## **Oakwood Manor Request for Proposals (RFP) – Addendum 1**

### **March 12, 2024**

# SVdP OAKWOOD MANOR APARTMENTS- REHABILITATION

PERMIT SET: NOVEMBER 2023

A001

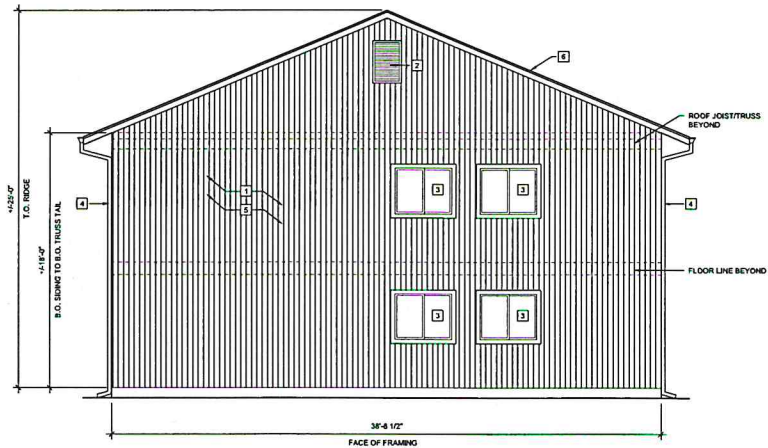
The Scope of Work and Permit Drawings have been updated to correct omissions in Section 3. Scope of Work (RFP v2 pg. 3 and 4). Updates include; 1) Building 2 needs sump pumps and related electrical work for a total of 5 buildings and 10 pumps, and 2) Contractors may need to repair or replace existing drainage lines at building 1 and building 2, as needed. Corrections highlighted in **red** below. See Appendix B for updated Permit Drawings and location of building 2 pumps.

- The following work is required at Buildings 1, **2**, 11, 12, and 13.
  - Replace two (2) sump pumps at four (**5**) buildings. One pump in the existing sump manhole and one in basement at bottom of stairs. As part of the proposal, specify the model/make for the replacement pump equipment.
  - Replace electrical lines serving new pump equipment.
  - Clean and test existing drainage lines to confirm function and performance. **Repair or replace existing drainage lines as needed.**
  - NOTE: Buy America, Build America requirements apply to any iron or steel components, **including pumps.**

1. REPLACE SUMP PUMP AND REPAIR/REPLACE BROWN LINE AS NEEDED
2. REPLACE CONDUIT, WIRING, AND INSTALL NEW BREAKER FOR OUT-  
SUMP PUMP. ELECTRICAL PANEL LOCATED IN BASEMENT OF ADJACE-  
BUILDING.
